## Planning Commission Staff Report

**SUBJECT:** P14-1186

**PURPOSE:** Application for Design Review (DR) approval to construct an approximately 6,841-square-foot two-story custom home as well as related landscape and site improvements including approximately 23,817 square feet of grading

**LOCATION:** 8019 Golden Eagle Way

Figure 5, below, is a copy of the proposed site plan.

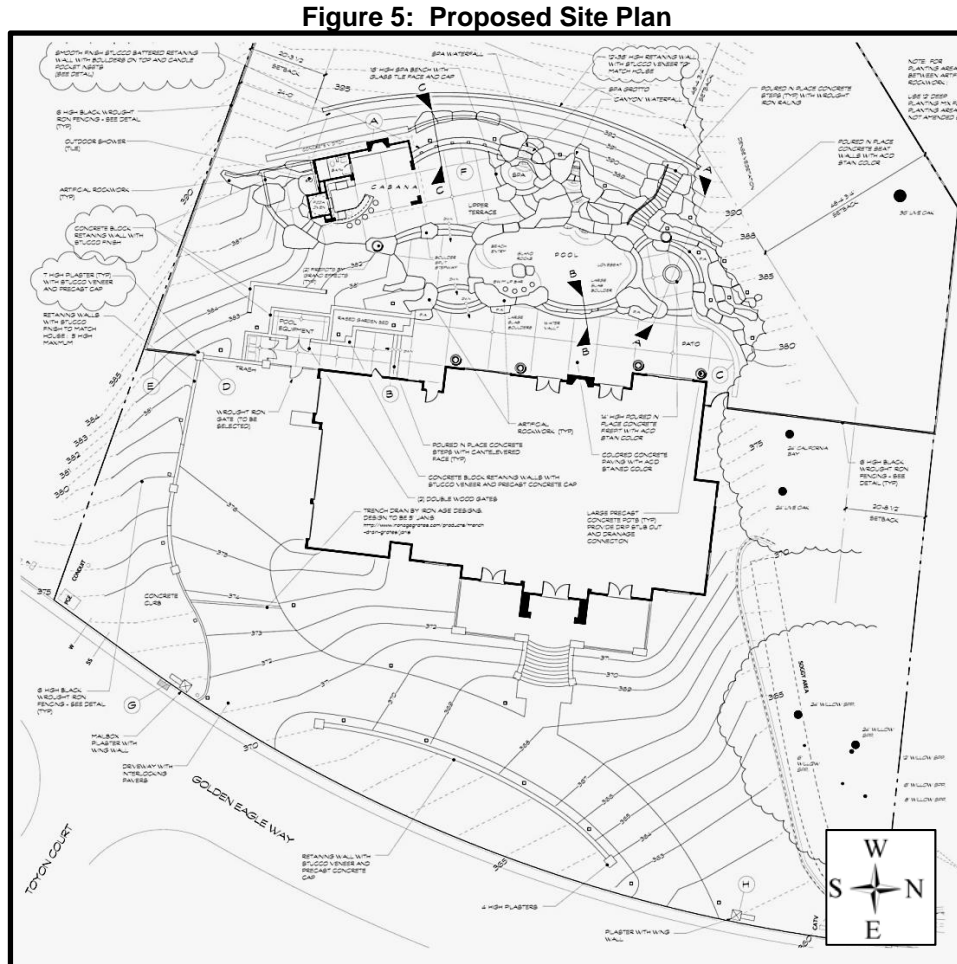
Staff has reviewed the proposed grading in context of the subject site and surrounding properties and feels that as designed it is appropriate to approve grading up to 23,817 square feet or approximately 50.45% of the lot area. This includes any disturbance of the surface area of the site as grading, including the area beneath the home, driveways and walkways, and landscaping and garden areas. Staff believes that the proposed grading is appropriate and will include a limited change to topography of the site. The area along Golden Eagle Way is relatively flat and requires little grading for the proposed driveway and entry to the home. The area located beneath the home, approximately 5,344 square feet, is also included within the total grading area but is not visible. The majority of the grading will be located to the rear of the home and will not be visible from the public right-of-way. Staff feels that the rear yard improvements have been designed to be built into the hillside to disturb as little area as possible and are consistent with the intent of the guidelines. In addition, requiring a reduction in grading may require additional retaining walls throughout the site, creating a more substantial visual impact and disruption of the natural topography.

**ALEXANDER & ASSOCIATES INC.**  
 REGISTERED PROFESSIONAL ENGINEERS  
 995 OLD BERNAL AVE. SUITE 10, PLEASANTON, CALIFORNIA (925) 462-2826

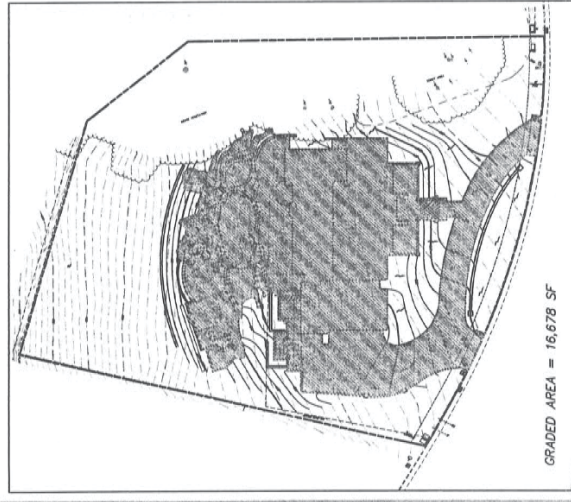
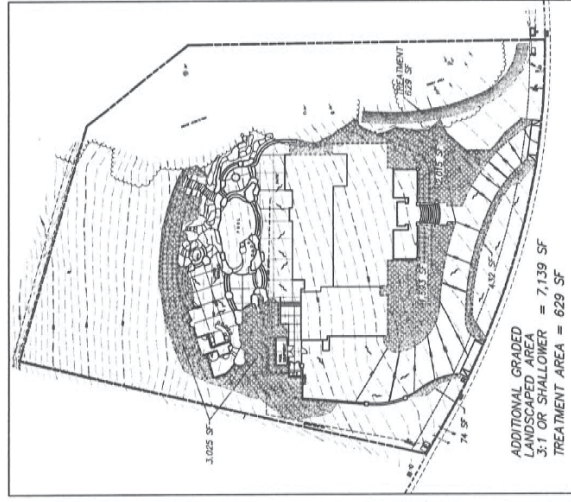
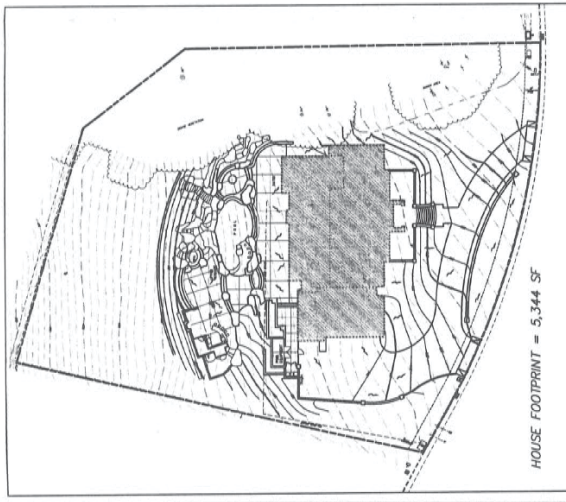
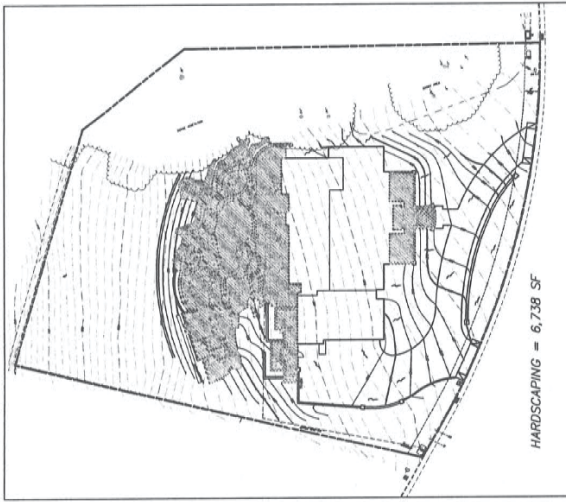
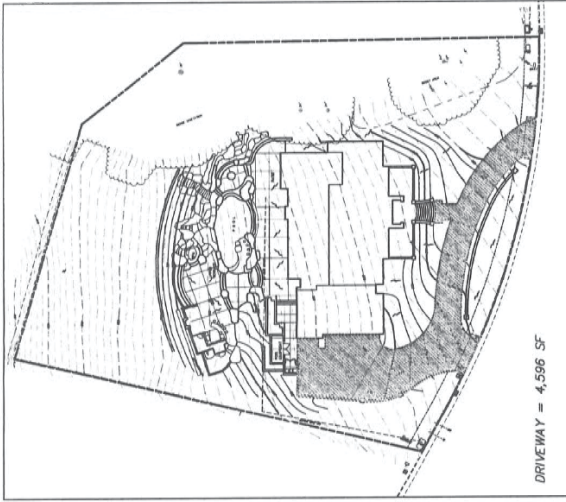
As a final note on grading, on February 5, 2015, Gary Monzo reviewed materials submitted to the Planning Department concerning the 8019 Application, including the grading plan from Alexander & Associates, Inc. (“Grading Plan”) (Attached hereto as Attachment K) which purportedly provides a complete grading plan and calculates the grading square footage for all areas on the property. That map identifies total grading for the house (5,344 s.f.), hardscape (6,738 s.f.), driveway (4,596 s.f.) and landscaping at a slope of 3:1 or shallower (7,139 s.f.). Consistent with the Guidelines, the total grading for the 8019 Application would thus be 23,817 – well in excess of the maximum amount allowed under the Guidelines and your October 14, 2014 letter. That same day, however, my client raised this issue with you, to which you advised him that the Planning Department changed its interpretation of the grading guidelines to provide that the term “exterior gardens” did not include landscaping, thus making the grading compliant with the Guidelines.<sup>6</sup>

Moreover, notwithstanding the interpretation issues outlined above, there appears to be a gross misrepresentation of the grading area as shown on the Grading Plan, when compared to the actual Planting Plan (undated) submitted by Martin Hoffmann (“Planting Plan”). We presume that the Planting Plan is part of the Planning Department’s records for the 8019 Application, and specifically note that when examining page L-3 of the Planting Plan, it appears that the 8019 Application anticipates landscaping on both the northeast and southeast corners of the property, as well as the easternmost border between the street and driveway. However, notwithstanding these very clear markings on the Planting Plan, none of these areas appear “shaded” in the Grading Plan, let alone in the landscaping portion thereof.

Again, while this may be an oversight or miscalculation as between outdated plans and calculations, the frequency of which these issues are arising is disconcerting. Indeed, just eyeballing these "unshaded" areas in Grading Plan which appear to be landscaped per the Planting Plan, there may be another several hundred square feet wholly unaccounted for in the Grading Plan. In short, until we have a clear set of plans identifying all grading, and which are consistent with all other plans on in the 8019 Application, any decision thereon would simply be made on incomplete information.
